MONTICELLO NUCLEAR GENERATING PLANT

ITS Section 3.5,
Emergency Core Cooling Systems (ECCS)

**ITS SECTION 3.5
EMERGENCY CORE COOLING
SYSTEM (ECCS) AND REACTOR
CORE ISOLATION COOLING SYSTEM
(RCIC)**

ITS 3.5.1, Emergency Core Cooling System (ECCS) - Operating

SR 3.5.1.10

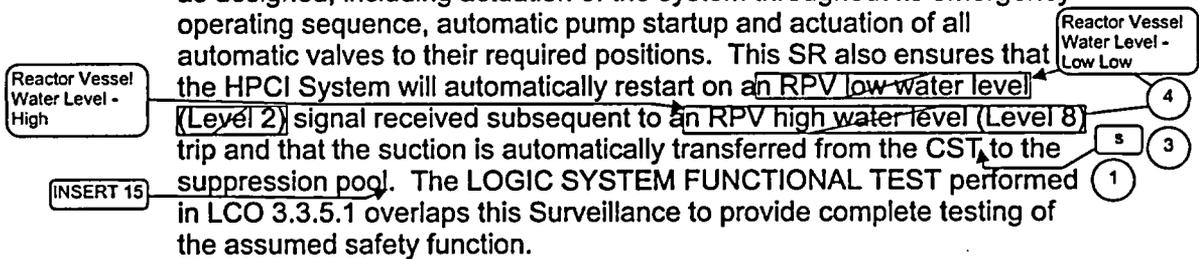
The ECCS subsystems are required to actuate automatically to perform their design functions. This Surveillance verifies that, with a required system initiation signal (actual or simulated), the automatic initiation logic of HPCI, CS, and LPCI will cause the systems or subsystems to operate as designed, including actuation of the system throughout its emergency operating sequence, automatic pump startup and actuation of all automatic valves to their required positions. This SR also ensures that the HPCI System will automatically restart on an RPV low water level (Level 2) signal received subsequent to an RPV high water level (Level 8) trip and that the suction is automatically transferred from the CST to the suppression pool. The LOGIC SYSTEM FUNCTIONAL TEST performed in LCO 3.3.5.1 overlaps this Surveillance to provide complete testing of the assumed safety function.

The 18 month Frequency is based on the need to perform the Surveillance under the conditions that apply during a plant outage and the potential for an unplanned transient if the Surveillance were performed with the reactor at power.

INSERT 16**SR 3.5.1.13**

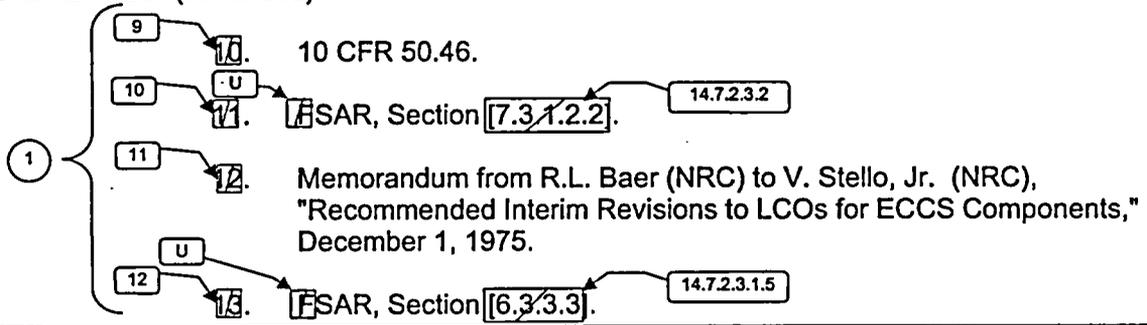
The LPCI System injection valves, recirculation pump discharge valves, recirculation pump suction valves, and the RHR discharge intertie line isolation valves are powered from the LPCI swing bus, which must be energized after a single failure, including loss of power from the normal source to the swing bus. Therefore, the automatic transfer capability from the normal power source to the backup power source must be verified to ensure the automatic capability to detect loss of normal power and initiate an automatic transfer to the swing bus backup power source. Verification of this capability every 24 months ensures that AC electrical power is available for proper operation of the associated LPCI injection valves, recirculation pump discharge valves, recirculation pump suction valves, and the RHR discharge intertie line isolation valves. The swing bus automatic transfer scheme must be OPERABLE for both LPCI subsystems to be OPERABLE. The Frequency of 24 months is based on the need to perform the Surveillance under the conditions that apply during a startup from a plant outage. Operating experience has shown that the components usually pass the SR when performed at the 24 month Frequency, which is based on the refueling cycle. Therefore, the Frequency was concluded to be acceptable from a reliability standpoint.

SR 3.5.2.1 and SR 3.5.2.2

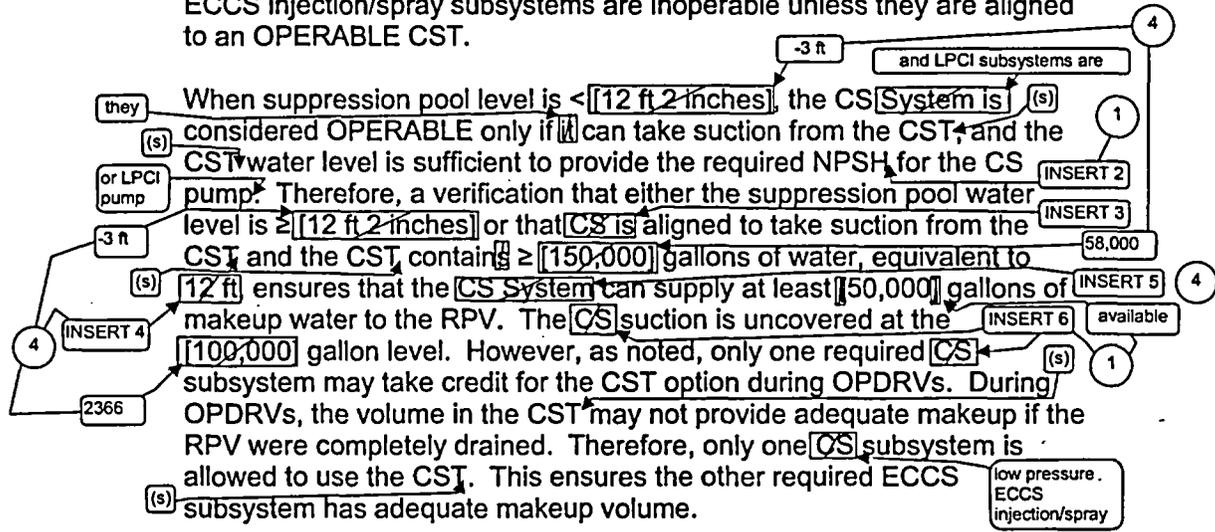
3 ft

The minimum water level of [12 ft 2 inches] required for the suppression pool is periodically verified to ensure that the suppression pool will provide adequate net positive suction head (NPSH) for the CS System and LPCI subsystem pumps, recirculation volume, and vortex prevention. With the suppression pool water level less than the required limit, all ECCS injection/spray subsystems are inoperable unless they are aligned to an OPERABLE CST.

The 12 hour Frequency of these SRs was developed considering operating experience related to suppression pool water level and CST water level variations and instrument drift during the applicable MODES. Furthermore, the 12 hour Frequency is considered adequate in view of other indications available in the control room, including alarms, to alert the operator to an abnormal suppression pool or CST water level condition.
